ADDENDUM NO. 2
TO THE CONTRACT DOCUMENTS
for the construction of

Date: 6/18/18
Project No.: 691778

SHAMROCK, BLALOCK & HOOPER RESERVOIRS – WATER QUALITY IMPROVEMENTS

CLAYTON COUNTY WATER AUTHORITY
CLAYTON COUNTY, GEORGIA

DWG	50-E-8
DATE	APRIL 2003
PROJ	169760.CD

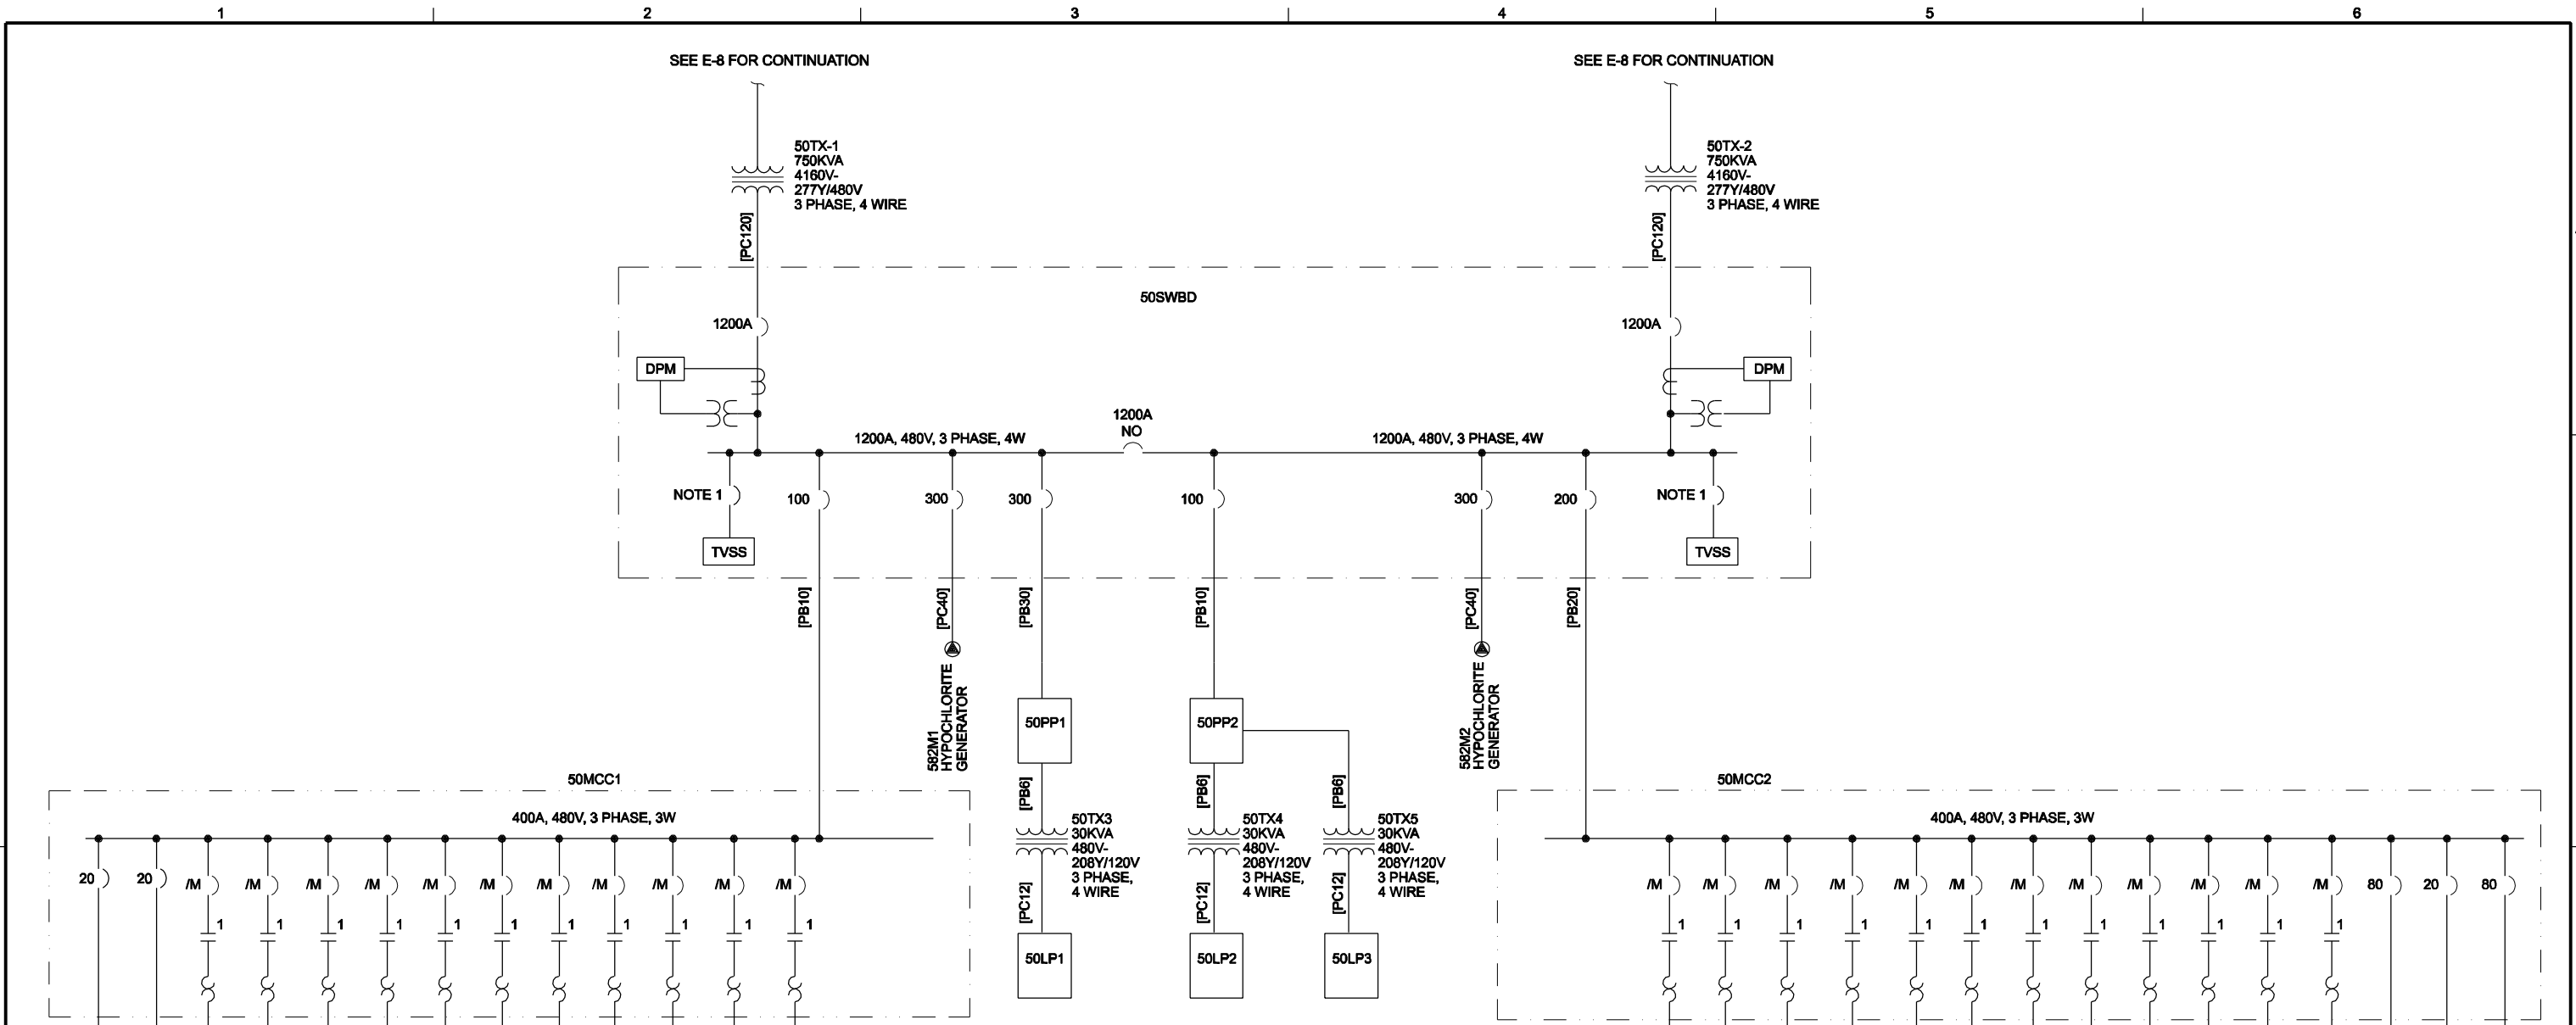
CCIR NO. 013
 ON 50-E-8, TRANSFORMER 50TX5 WAS ADDED AS A RESULT OF ADDENDUM #3. DRAWING 50-E-8 DOES NOT SHOW THE LOCATION FOR TRANSFORMER 50TX5. THERE SHOULD BE SPACE NEXT TO 50TX3 AND 50TX4 TO SET 50TX5 IF THE TRANSFORMERS ARE MOUNTED CLOSER TOGETHER THEN SHOWN ON DRAWING 50-E-8. THE CONTRACTOR MAY CHOOSE TO MOUNT 50TX5 NEXT TO PANEL 50LP3 IF THIS IS AN EASIER LOCATION, HOWEVER, BE SURE FOUR FEET MINIMUM IS MAINTAINED BETWEEN ANY EQUIPMENT AND THE MCC'S IN THE MIDDLE OF THE ELECTRICAL ROOM.

PCO NO. 046A
 PLEASE MAKE THE FOLLOWING ELECTRICAL REVISIONS TO SODIUM HYPOCHLORITE SYSTEM GENERATOR/RECTIFIERS 582M1 AND 582M2:

PROVIDE AND INSTALL (REPLACE) THE TWO (2) EXISTING HYPOCHLORITE 400A FEEDER CIRCUIT BREAKERS IN 50SWBD WITH TWO (2) 300A CIRCUIT BREAKERS. PROVIDE CREDIT AMOUNT FOR RETURNED 400A CIRCUIT BREAKERS OR TURN OVER TO CCWA AS SPARES.

PROVIDE AND INSTALL PERMANENT MEANS FOR LOCKING NEW 300 A BREAKERS IN OPEN POSITION.

CABLE AND CONDUIT FEEDER FROM 50SWBD TO RECTIFIERS 582M1 AND 582M2 TO REMAIN TO SAME (SEE 50-E-8).

PROVIDE AND INSTALL POWER DISTRIBUTION BLOCK (SQUARE D CLASS 9080 TYPE LB, #LBA385202 OR EQUAL) IN EACH OF THE TWO (2) RECTIFIER CABINETS 582M1 AND 582M2.

IN EACH RECTIFIER CABINET (582M1 AND 582M2):

LAND FEEDER 3 PHASE POWER WIRES (6 TOTAL CONDUCTORS) ON DISTRIBUTION BLOCK PROVIDE AND INSTALL THREE (3) #3/0 CONDUCTORS FROM DISTRIBUTION BLOCK TO EXISTING RECTIFIER CONTACTOR. LAND FEEDER NEUTRAL AND GROUND CONDUCTORS TO FRAME OF CABINET.
